Appeal Period Expires <u>3/14/18</u>	Town of Essex, Vermont Application for Zoning Permit www.essex.org	Application Date <u>1/1</u>
Zoning District <u>RT</u>		Permit Number <u>2018-030</u>

TOWN OF ESSEX, VERMONT
APPLICATION FOR CURB CUT / UTILITY PERMIT

Re: Underground Utility Service at #5 Indian Brook Road

RURAL DRIVEWAY

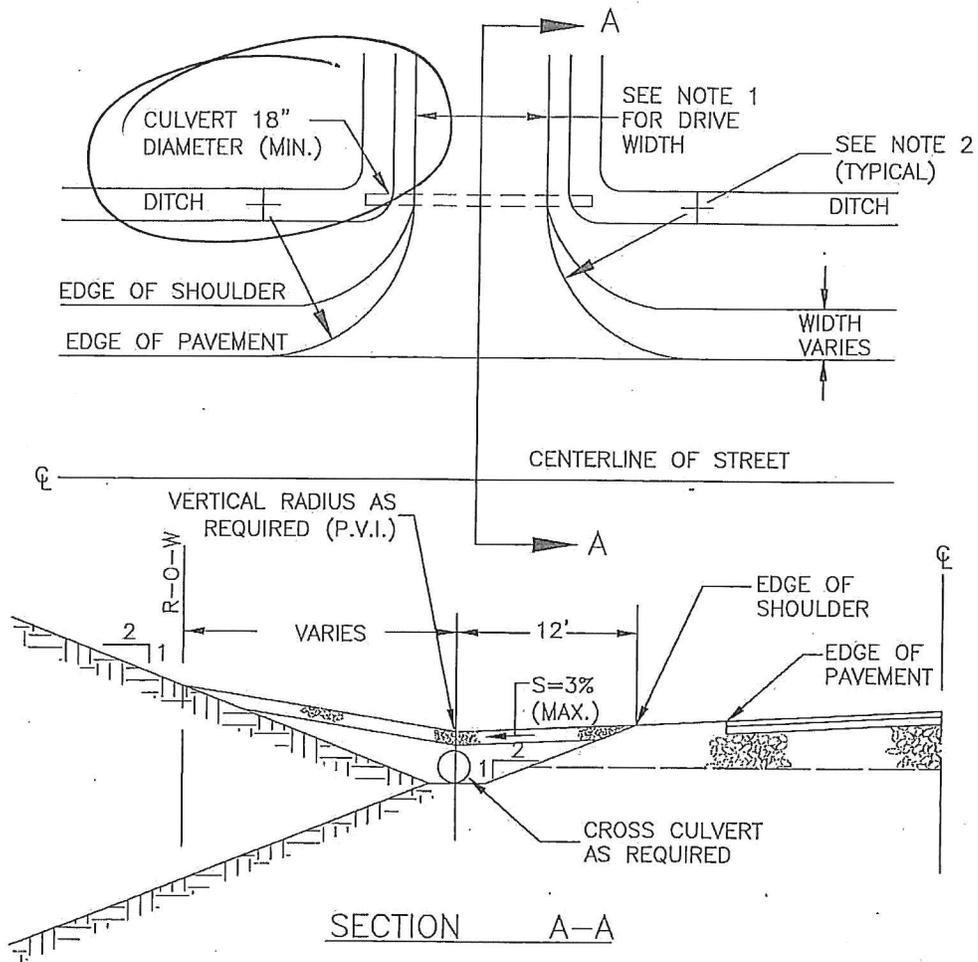
" DRIVE WIDTH IS TO BE LIMITED TO 10 FT.

" APRON RADIUS TO BE 25'

" CULVERT IS REQUIRED

SEE ATTACHED "RURAL DRIVEWAY" DETAIL

TYPE B RURAL ROAD
(GRAVEL)

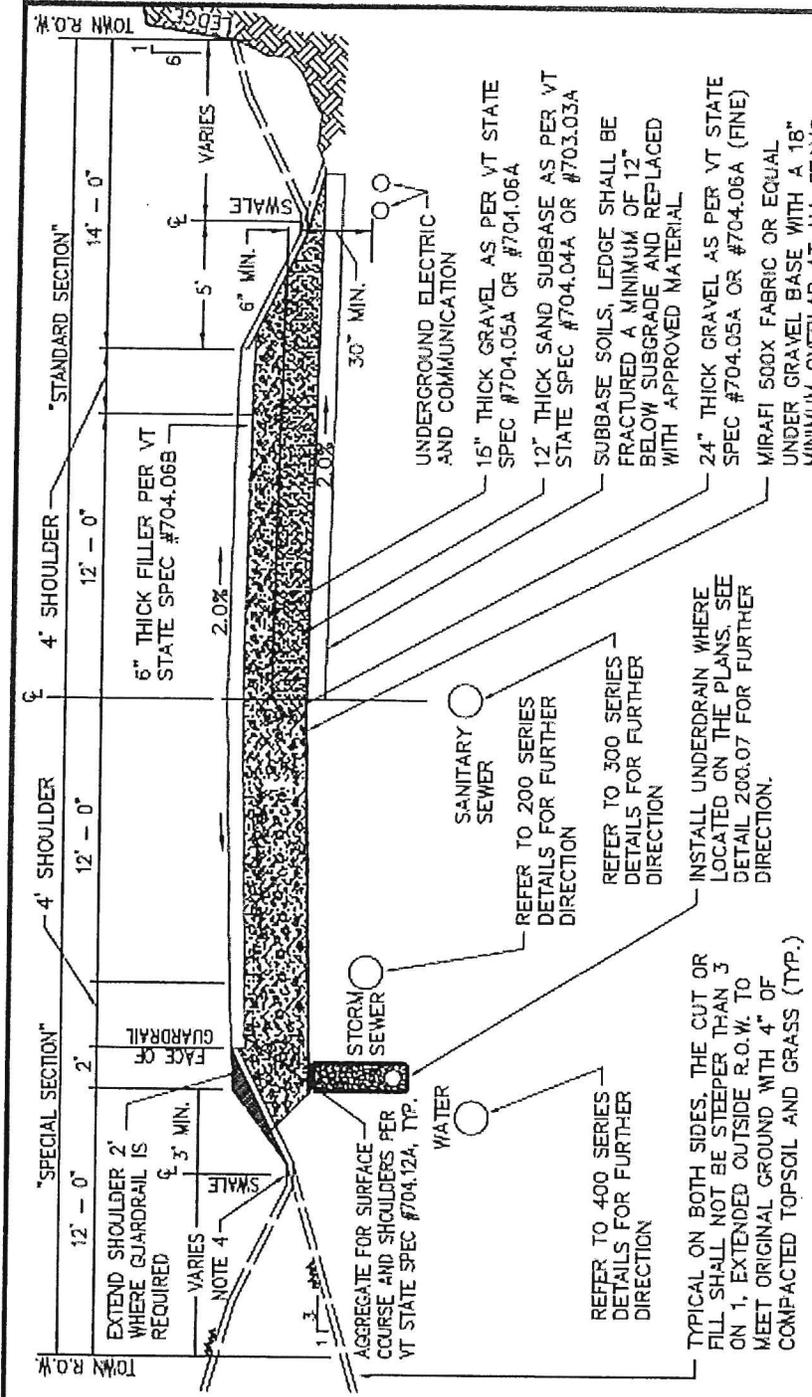
Town of Essex Standard Detail No 100.04, attached, requires that conduit be buried at a depth of at least 30 inches below the bottom of the roadside ditch.
